# Cree, Inc. Product Change Notification

## PCN-PW064: Change of Wafer Diameter from 100mm to 150mm for 1200V 3rd Generation MOSFET (C3M)

Figure 1: New gate pad dimensions.

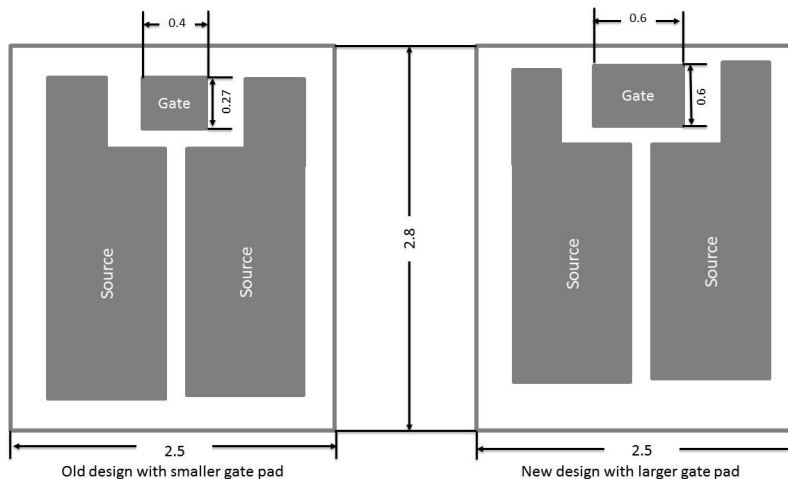
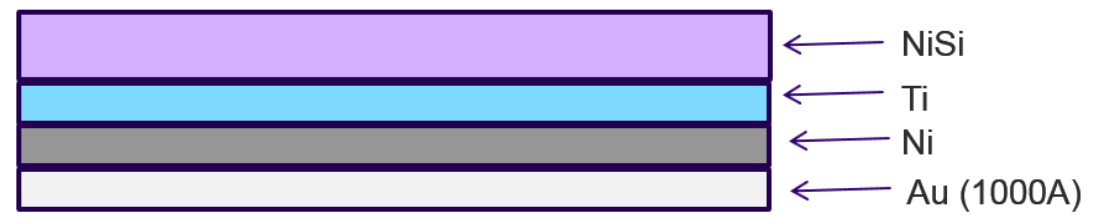
Gate pad size increases from (0.4mm x 0.27mm) to (0.6mm x 0.6mm). This increase in gate pad size improves wire-bonding by providing a larger area for the gate wire. There is no change to the overall die size.
